Enclosure 1

DOE Response to Outstanding EPA Concerns for Shielded Containers

SCA CONTACT DOSE RATE SURVEY AREAS

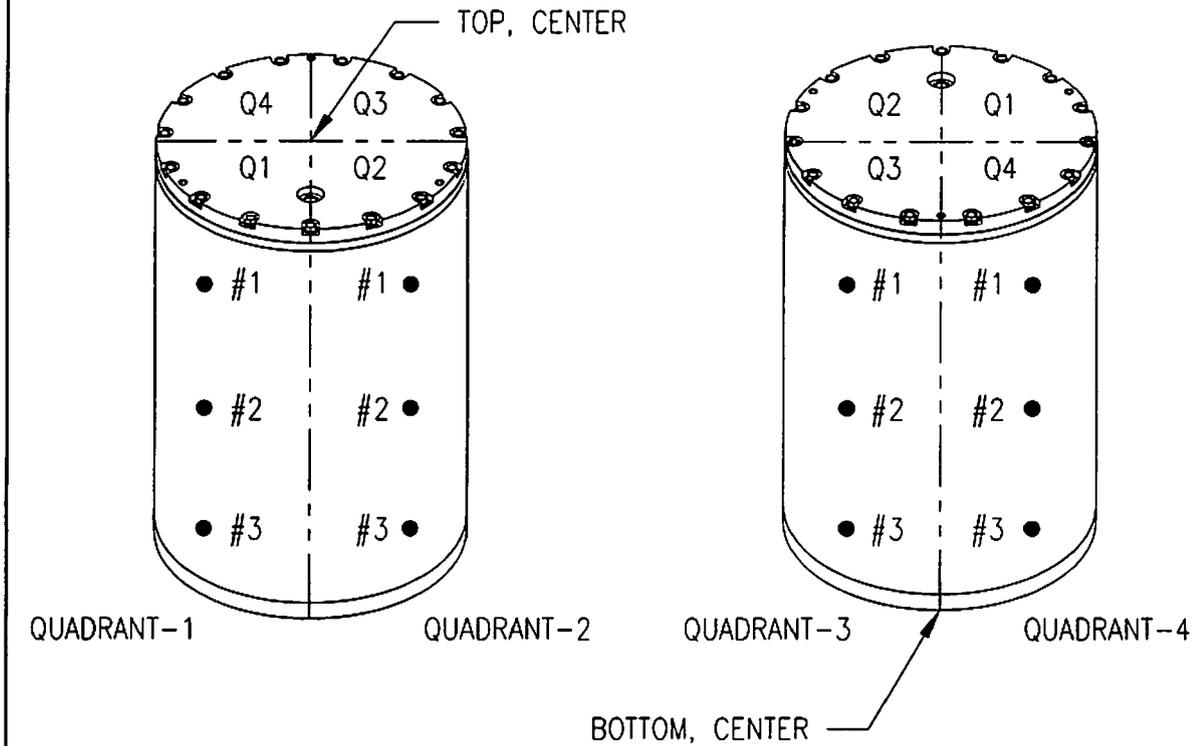
Based on review of the initial dose rate measurement procedure (CCP-TP-081, *Shielded Container Assembly Loading*) provided on May 16, 2013, it was not clear to the EPA how the DOE would ensure that maximum dose rate would be captured on the outside of the shielded container.

The physical demonstration on June 13, 2013 showed that, in practice, dose rate measurements are taken over the entire outer surface of the shielded container. The following discussion provides an in-depth description of how the measurements are conducted. The revised CCP procedure, CCP-TP-081, *Shielded Container Assembly Loading*, is included as Attachment 1.

The surface of the shielded container is divided into 14 sections for surface dose measurement. The cylindrical surface of the container is divided into four quadrants with three sections (top, middle, and bottom) per quadrant, or a total of 12 sections on the cylindrical surface. The top and bottom of the container are two additional sections, for a total of 14 sections. Within each section, the generator site RadCon technician will search for the (local) maximum radiation dose rate and record this value. The maximum of the 14 values for the individual sections is taken as the dose rate of record for the WDS. Procedure CCP-TP-081, *Shielded Container Assembly Loading*, is consistent with this approach. The CCP procedure governing surface dose measurements for the DOE complex will be modified to require the RadCon technician to search for the local maximum within each section. Recent data from measurement of surface dose rates for two shielded container assemblies (SCAs) using the CCP procedure are listed in Table 1.

The cylindrical body of the SCA is divided into four quadrants, each of which is subdivided into three areas as shown on Attachment 2, page 1. The top of the SCA and the bottom of the SCA are two more areas, for a total of fourteen (14) areas on each SCA. Each separate area is completely surveyed, and the highest contact dose rate measurement for each area is recorded on Attachment 2, page 2.

[Q.2] Use the orientation of the filter vent to identify the four quadrants of the SCA cylindrical body (Q1 - Q4). Contact dose rate measurements shall be taken at three areas in each quadrant (e.g., Q1-#1, #2, #3...) and at the top and the bottom of the SCA, such that the entire external surface of each SCA is surveyed.
